PROPOSED RESIDENTIAL REDEVELOPMENT
PHOENIX WORKS, CASTLEFIELD, MANCHESTER

Highways Technical Note 01

- 1.1.5 The highway-related comments are summarised in this Highways Technical Note 01 (HTN01) and a copy of the full consultation response from the LHA at MCC, dated 26th February 2021, is contained in **Appendix 1** to rear of this report.

PLAN OF ITEMS RAISED BY THIS AUDIT

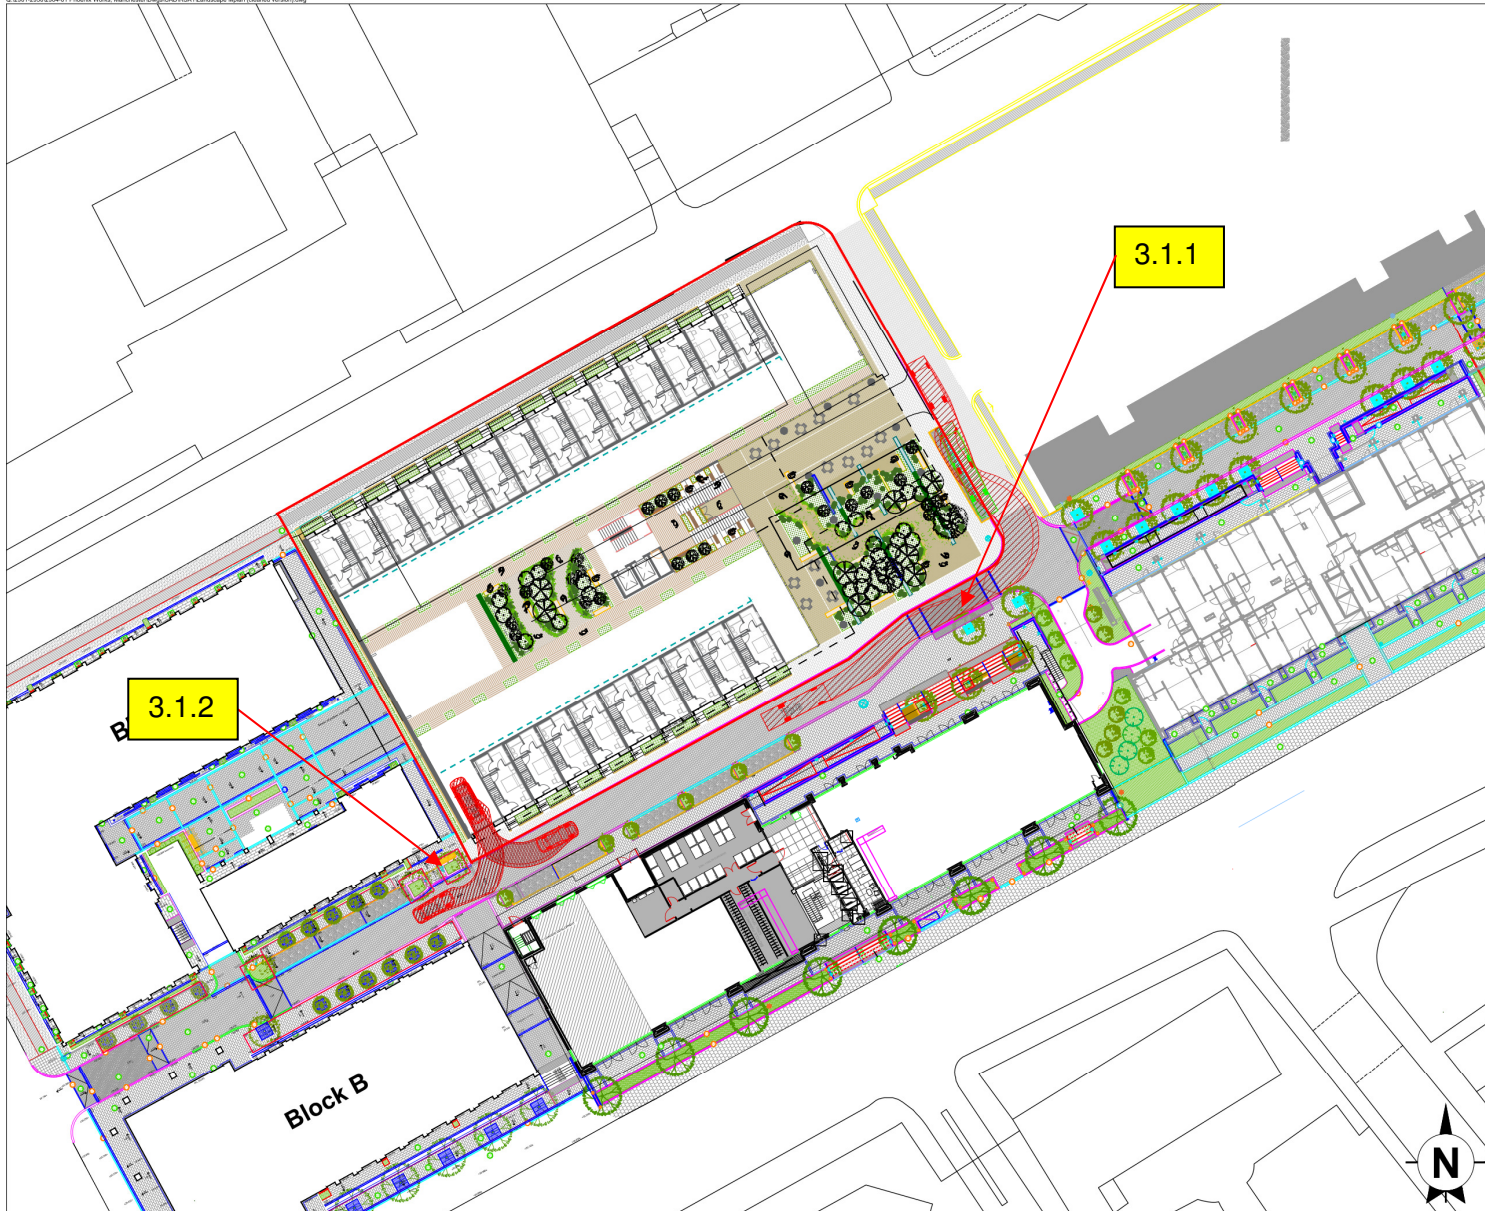
- 11.3.3 The RSA is contained in **Appendix 7**. The RSA raises only two problems / recommendations, as follows:
- Concern is expressed that due to the close proximity of the junction with Bentinck Street and relatively limited intervisibility between the two roads that traffic could turn from Bentinck Street into Spinners Way and fail to sufficiently appreciate approaching traffic travelling along Spinners Way potentially resulting in head-on conflict or force hazardous reversing manoeuvres; and

- it is noted that proposed trees/planters fall within the visibility envelope and as such could reduce visibility for drivers attempting to turn out of the junction increasing the risk of failure to give-way conflicts.

SUMMARY: Reduced visibility due to planting

Whilst a west side visibility splay of 2 x 18 metres has been annotated, it is noted that proposed trees/planters fall within the visibility envelope and as such could reduce visibility for drivers attempting to turn out of the junction increasing the risk of failure to give way conflicts.

- 11.3.6 With regards to the second identified problem, the recommendation to ensure that visibility is maintained and clear of obstruction has been accepted. Further information on the level of achievable visibility from the proposed site access is also set out in **Chapter 5** of this report.

3.1.2	Reduced visibility due to planting	Yes	Yes	As detailed in the RSA recommendation, visibility splays from the proposed site access junction should be kept clear and maintained of all obstructions. Specific regard is made to the planters which fall within the visibility envelope to the west, as wider landscaping proposals along Spinners Way. It should be noted that the identified planters would comprise a kerbed planter with an upstand of 200mm and would not therefore impede on the visibility achievable to the west of the site access. Notwithstanding the above, it is noted that there is the potential for the trees / vegetation within these planters to partially obstruct visibility, if overgrown. To address this problem, members of the site management team will be responsible for maintaining the vegetation to ensure that it does not overgrow to the extent that it would obstruct visibility. Similarly, the site management team will also be responsible for ensuring that indiscriminate parking does not occur along Spinners Way which could also cause an obstruction to visibility for drivers attempting to turn out of the junction.
